Portland General Electric

Re: LC 80 – Portland General Electric Company’s 2023 Clean Energy Plan and Integrated Resource Plan Response to Initial Comments

Figure 1. Price Impact difference between Zero Additional EE and 50 MWa of additional EE

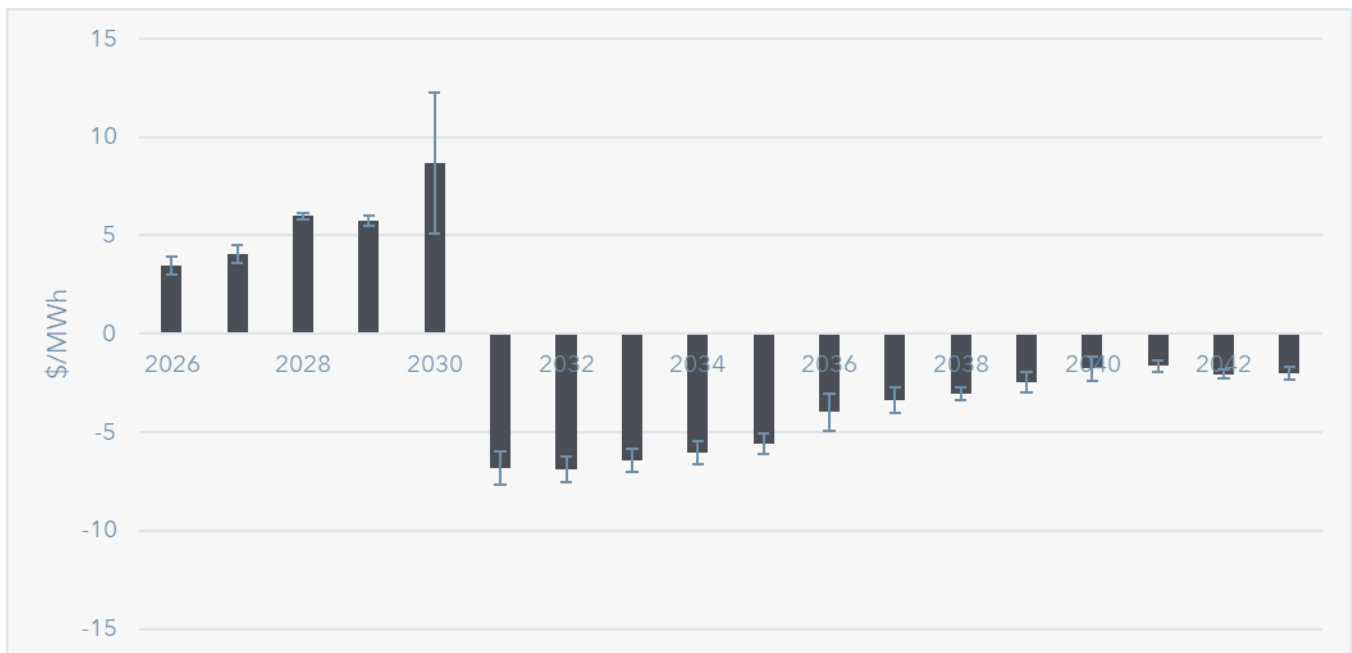
On the topic of how PGE approached and decided on the actions impacting energy efficiency (EE) and demand response (DR), Staff asked about how PGE’s modeling addressed direction from HB 2021 to consider EE DR resources in addition to non-emitting resources.³² Regarding not including additional EE in the Preferred Portfolio, Staff asked why PGE prioritized short-term cost impacts over long-term reductions and requested additional details on execution risk mentioned.³³ Staff also asked how PGE considered Senate Bill 1547 (ORS 757.054(3)) deciding on the role of additional EE.³⁴ Lastly, Staff asked for justification for not including additional EE in the Preferred Portfolio.³⁵

PGE notes that portfolio analysis found that when considering transmission constraints, EE can lower portfolio cost and risk. This finding, which highlights the potential benefits that EE can provide in alleviating transmission needs, is discussed in Chapter 12 Portfolio Analysis. That the Optimized EE portfolio selected 53 MWa of additional EE suggests that offsetting transmission need with up to 53 MWa of additional EE could reduce long-run portfolio costs.

Figure 1 highlights the difference in price impact between a portfolio with Zero addition EE and 50 MWa of additional EE. The 2030 impact would be \$9/MWh higher on average than the portfolio with zero additional EE. This translates to ~10% in the costs associated with generation resources relative to a portfolio without additional EE. Relative to 2024, in 2030 the 50 MWa EE portfolio is sees ~19% higher costs associated with generation resources relative to an ~8% increase in costs associated with generation resources for the portfolio with no additional EE.

Figure 2. The cyclical planning interaction between PGE and Energy Trust

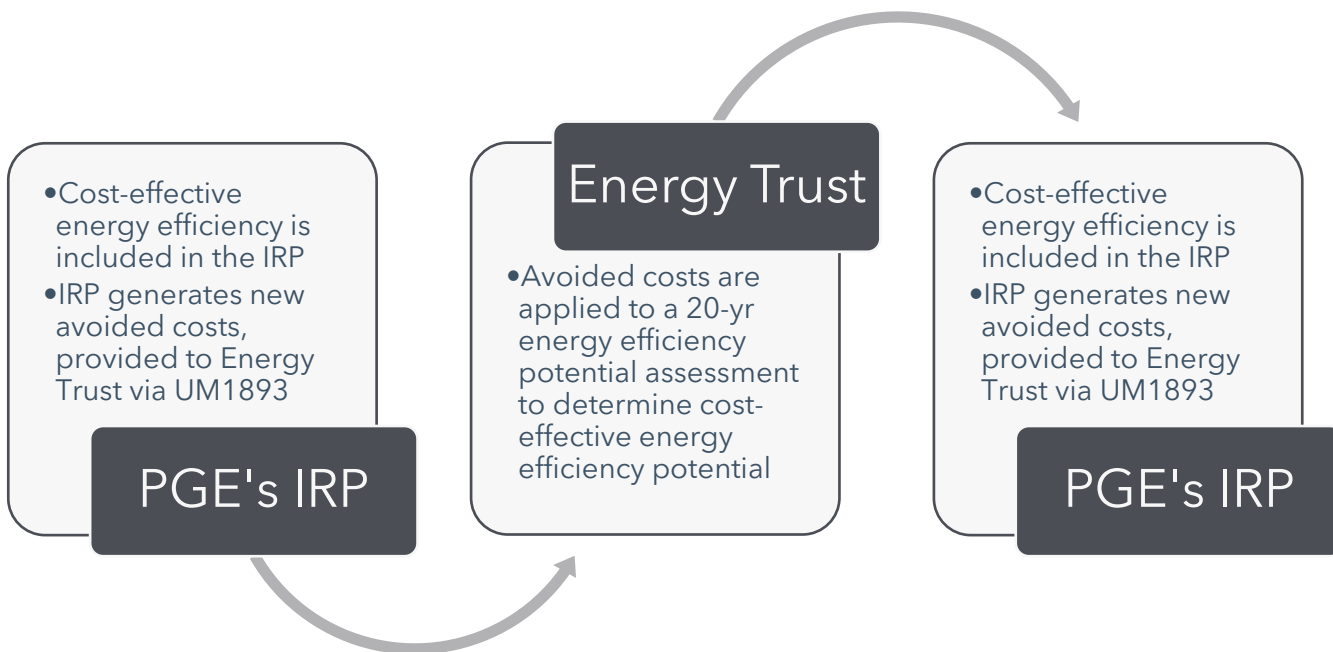
On the topic of Customer Actions, Staff ask if there is a discrepancy in the CEP/IRP since the Action Plan does not include non-cost-effective DR resources even though PGE’s CEP/IRP states that “...the IRP

The cyclical planning interaction between Energy Trust and PGE is shown in **Figure 2**.

Energy Trust’s role as statewide EE program administrator is to steward PGE customer dollars to realize savings for industrial, agricultural, commercial, and residential customers. The majority of PGE customer dollars that contribute to Energy Trust’s annual budget are ultimately provided to customers in the form of incentives. PGE supports Energy Trust via promotion (marketing and outreach funded from SB 838) and via Action Plan collaboration. Comprehensive Action Plans breakdown activities by customer program segment, Existing Buildings, Industrial & Agricultural, Residential, New Buildings, and Northwest Energy Efficiency Alliance (NEEA) funding, and support conservation measures including space and water heating and cooling, insulation, lighting, variable frequency drives, motors, refrigeration, wastewater treatment and custom incentives and strategic energy management as well as early design assistance and make-ready infrastructure. Utility-specific Action Plans, born out of House Bill (HB) 3141, go a step further to represent areas of joint investment and coordinate activity and are supported by workgroups – Community Engagement, Marketing and Outreach, Renewables, and Non-Wires Solutions - comprised of Energy Trust and PGE staff with charters that clearly articulate objectives and milestones.

Figure 3. WECC capacity installed by year and generation source

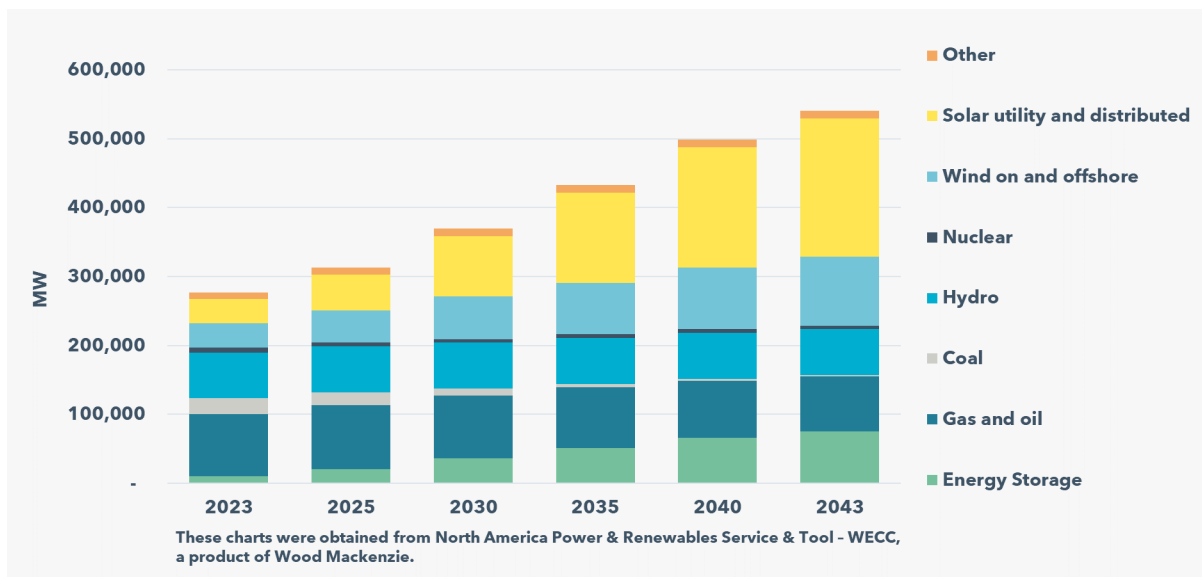
Regarding how PGE thermal resource dispatch would change due to changes in the resource mix and policies in the Western Interconnection, the CEP/IRP uses a Western Interconnection buildout, sourced from Wood-Mackenzie, that adds hundreds of thousands of MW of wind, solar, and storage resources to the West, while also retiring thermal generation, throughout the IRP planning horizon. This is shown in **Figure 3** (which is the same as Figure 20 in the CEP/IRP).
